Date: **29 July 2019**Our Ref: **190729FUS**

### Analysis of Acoustic Performance Tests and Ratings. Fusion Partitions.

Figure 1.- CSG-AP1 Reference curve not fitting data.

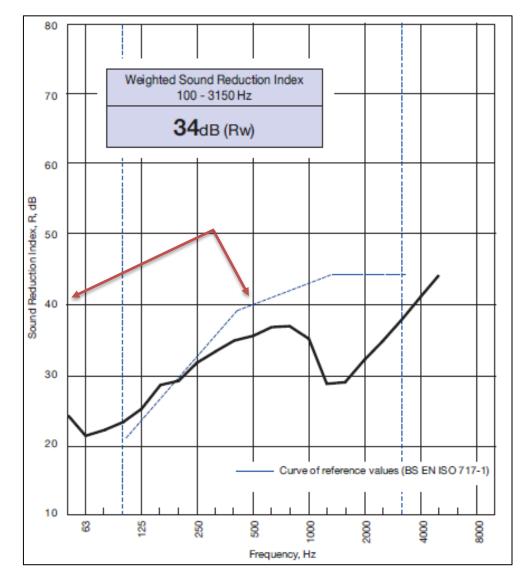
Four documents in the second category were found to have an inconsistency in the 1/3-band plot, as the ISO 717-1 reference curved was plotted without being fitted to the measured data. The  $R_w$  rating number is taken from this reference curve at 500 Hz once this reference curve has been fitted to the data. In these documents the reference curve returns a value of 40 dB  $R_w$  (as taken from the 500 Hz band, denoted by red arrows in figure 1) which is different from the stated  $R_w$  value.

My analysis of the measured data indicates that the stated  $R_{\rm w}$  value is *correct*, and only the placement of the reference curve in the plot is non-compliant with the rating standard data plotting guidelines, so I consider this to be a minor technical issue that does not change the quoted performance value. The documents with the wrongly fitted ISO 717-1 reference curve are:
